**GENOA CHARTER TOWNSHIP
PLANNING COMMISSION
PUBLIC HEARING
September 9, 2013
6:30 P.M.
AGENDA**

OPEN PUBLIC HEARING #1... Review of site plan, special use, and environmental impact assessment for proposed 16,120 square-foot gymnasium and classroom addition for Brighton Nazarene Church, located at 7669 Brighton Road in Section 25, petitioned by Brighton Nazarene Church.

Re: Brighton Nazarene Church Facility Expansion
Site Plan Review
Boss File No. 13-100

Attention:	Kelly Van Marter, AICP Assistant Township Manager and Planning Director
Subject:	Brighton Nazarene – Special Land Use and Site Plan Review #3
Location:	7669 Brighton Road – northwest corner of Brighton and Aljoann Roads
Zoning:	SR Suburban Residential District

SCALE: 1" = 50'
JOB NO. 13-100
DATE 5-31-13
SHEET NO. 4

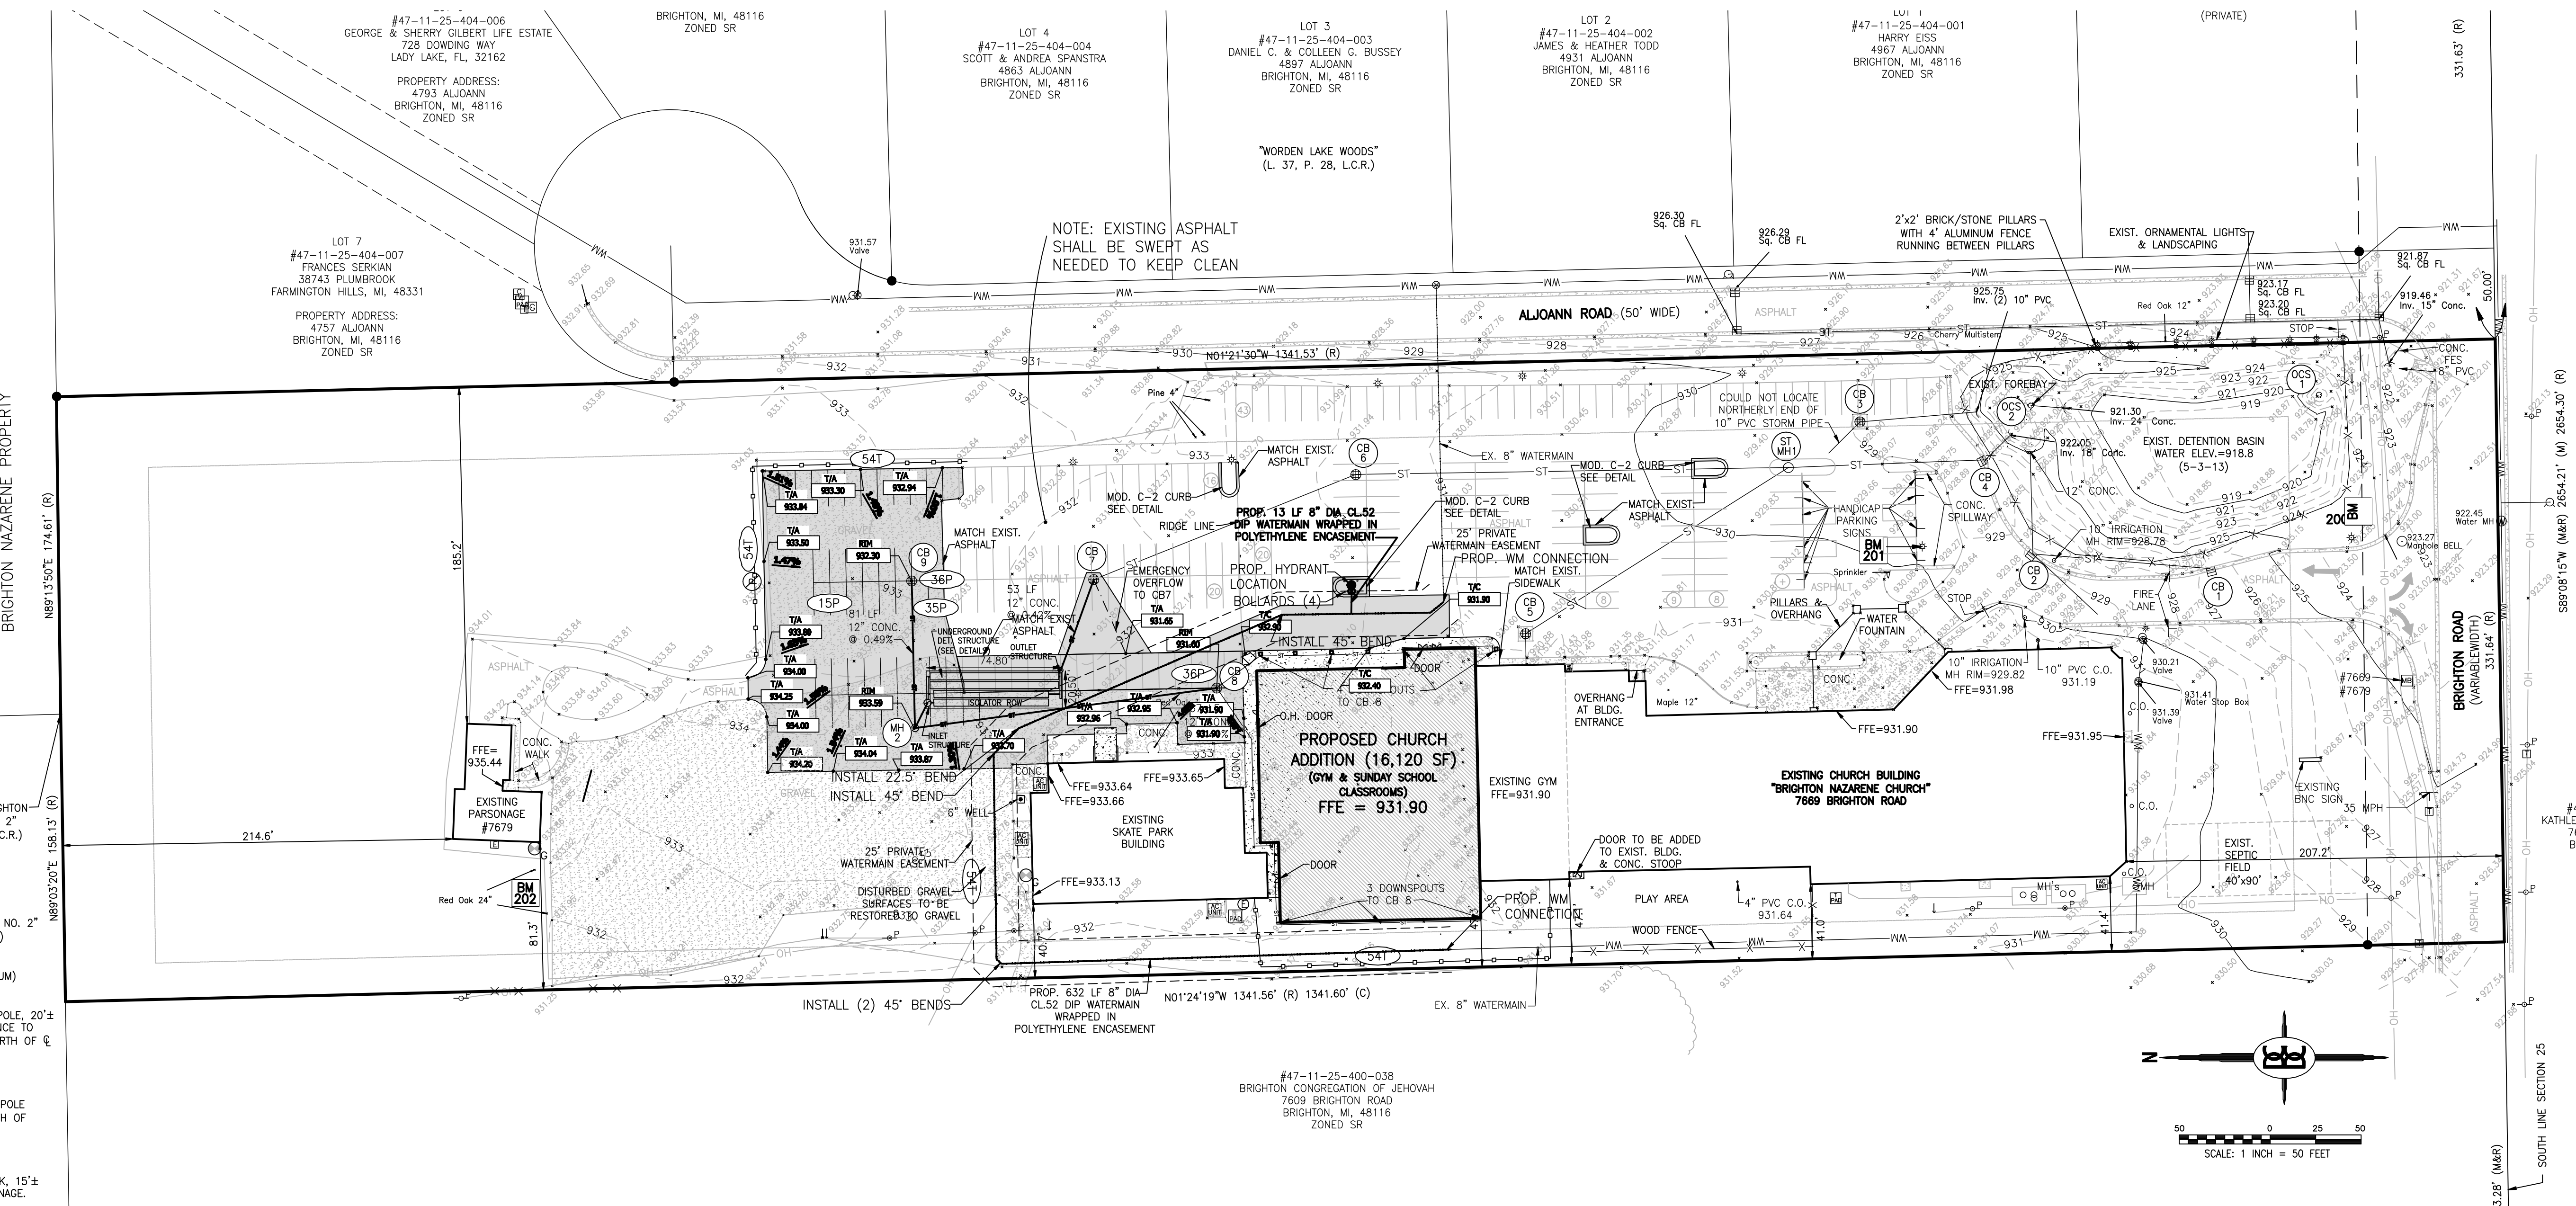
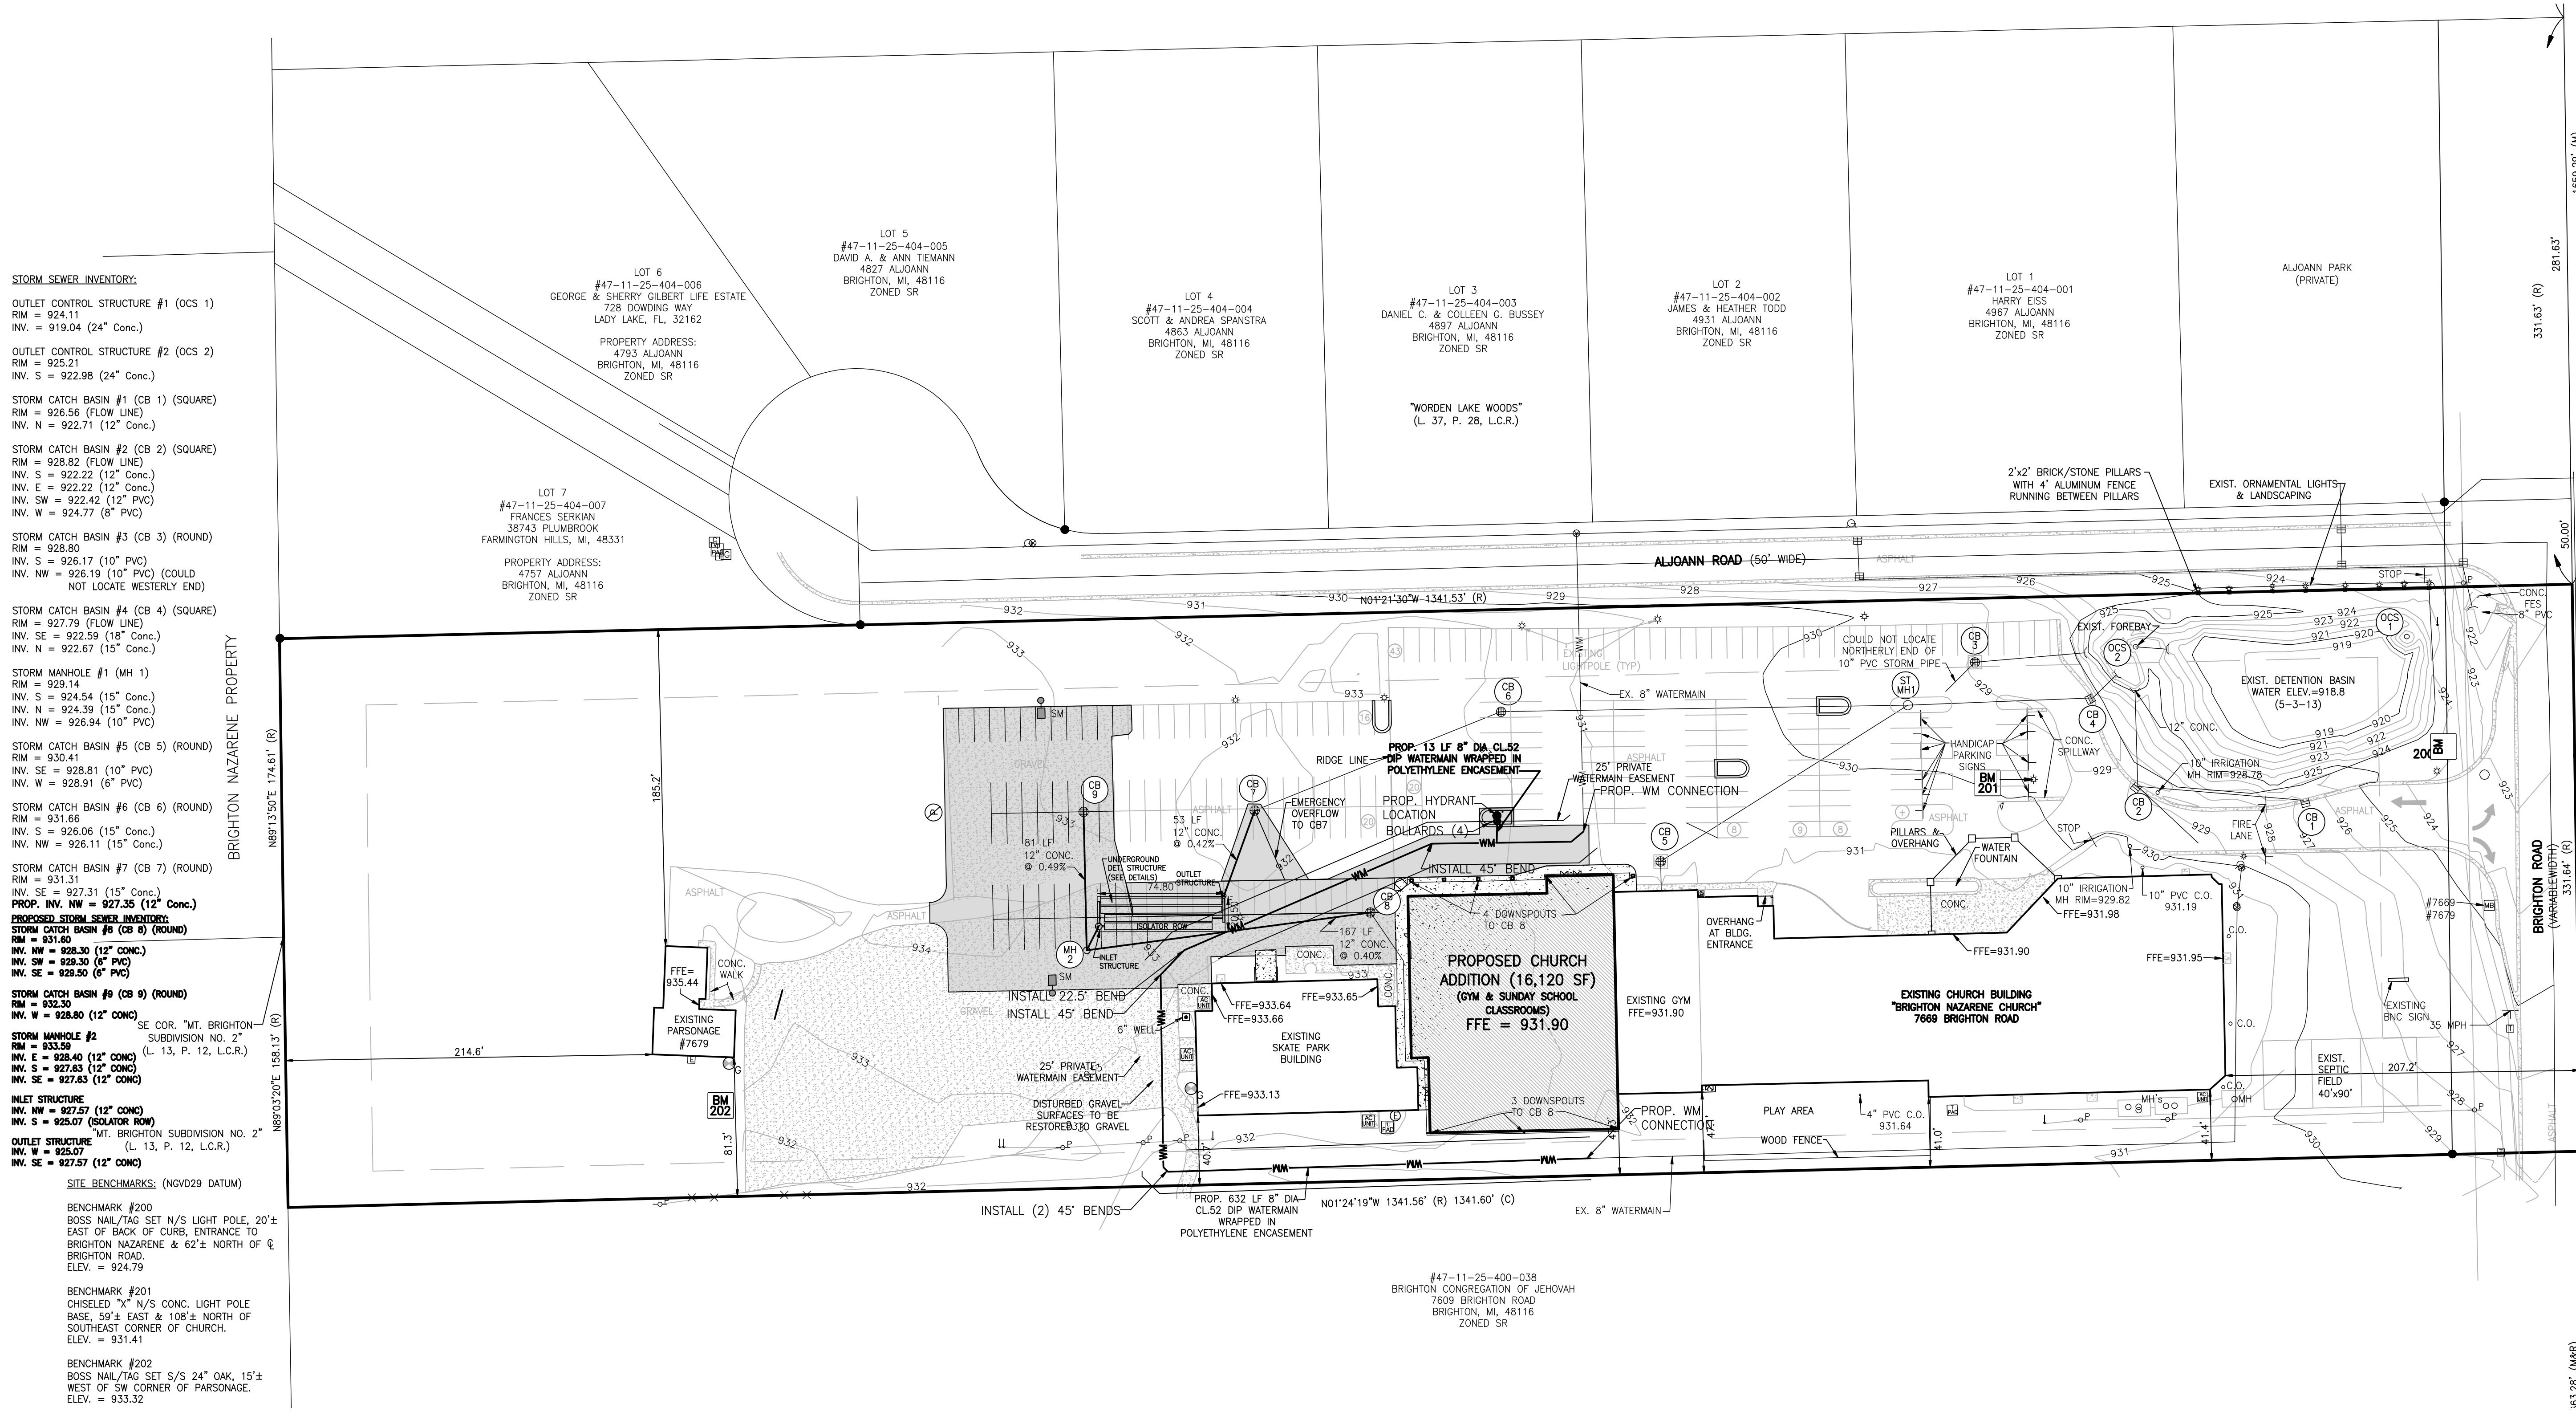
1. An additional fire hydrant near the bend adjacent to the west property line would be recommended to provide fire protection coverage to the western side of the site, as the addition of the new building will block previous access to this location. The length of hose to reach the NW corner of the skate park building is over 300 feet.

3. Water main should be at least 20 feet from any building, per standards. Petitioner should check the dimensions shown across the west side of the new addition to verify this clearance can be met. If it cannot, then a written request for a design exception would be needed for the owner to consider.

4. The location of the existing and any new water service connections should be clearly shown on the drawing. If the existing building water service currently enters the building where the proposed addition is planned to be, then commercial water service connection shall be show to be relocated to outside the proposed building footprint. If the locations of the existing service lines are unknown, then a note should be included on future construction drawings to locate the connection so the appropriate actions may be taken.

6. The proposed underground detention system was moved to better accommodate the storm water from catch basin 8.
7. Downspouts were added to the drainage plan on sheet 4. Roof drainage is to be piped to catch basin 8.

8. A Permanent private watermain easement note was added on sheet 4.
9. The watermain pipe type Cl. 54 was changed to Cl. 52 wrapped in polyethylene encasement to meet township standards.

10. Spot elevations were added to the proposed sidewalk on sheet 4 to help determine drainage patterns.
11. The "Stormwater Management Narrative" on sheet 4 was expounded upon to clarify the functionality of the underground detention system.

12. The lighting was adjusted to not exceed the 10-footcandle maximum on sheet 6.
13. Additional inverts, pipe length and slope notes were added to the drainage and utility plans to clarify the flow of the storm water on sheets 4 & 5.

END (NORTH)
ELEVATION
1/8"=1'-0"

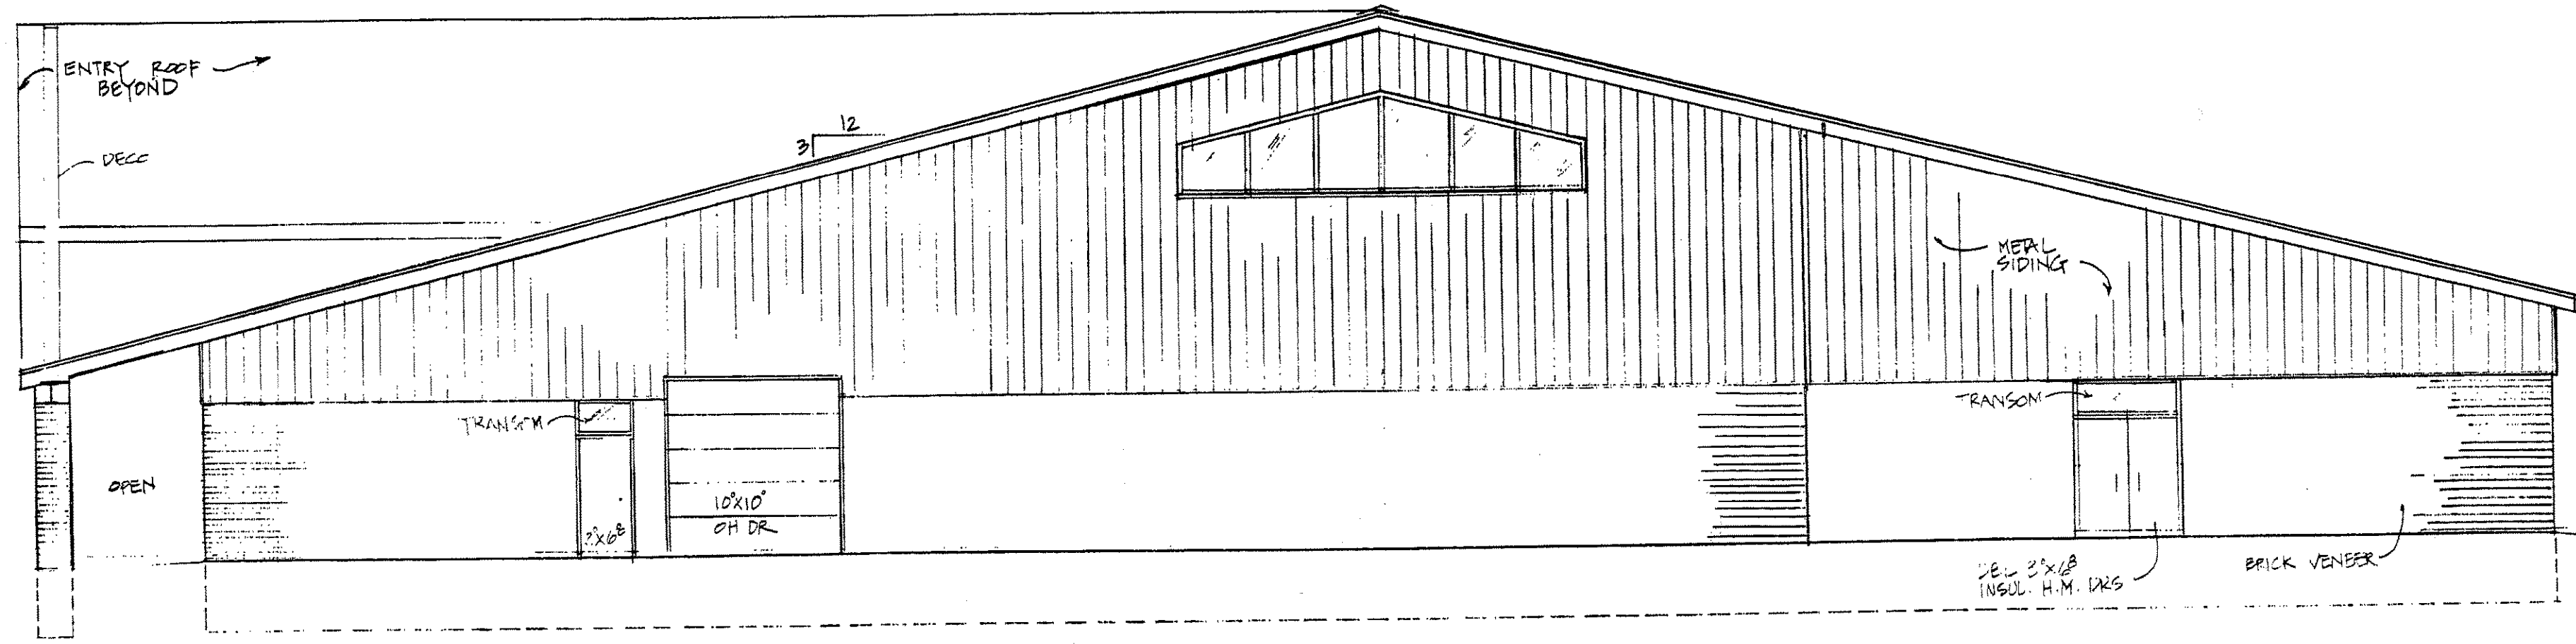
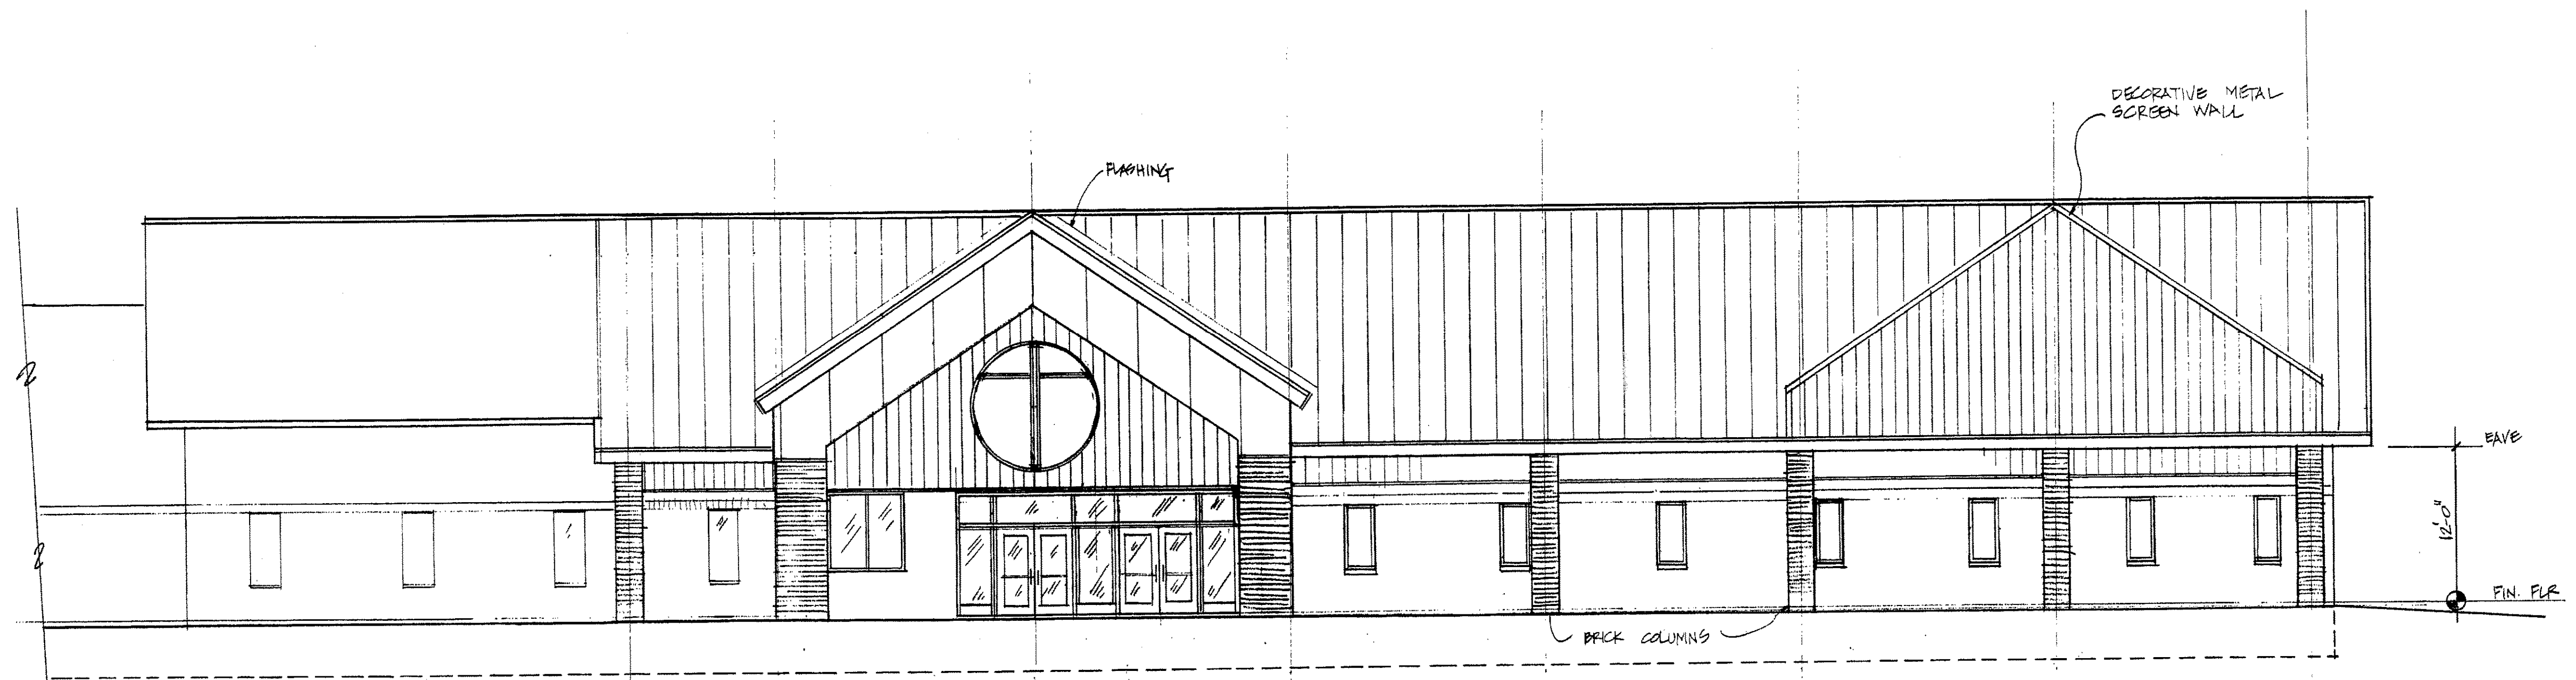
The elevation drawings submitted provide a building height of approximately 23 feet for the proposed addition; Section 3.04 establishes a maximum building height of 35 feet. This condition is met.

- 2. Building Materials and Design.** Proposed elevations, including colors and materials, are subject to review and approval by the Planning Commission. The submittal includes elevation views of two of the three building sides and generally utilizes a brick veneer and metal siding as primary materials. The east elevation includes brick columns matching those at the main church entrance. The addition also includes a pitched metal roof.
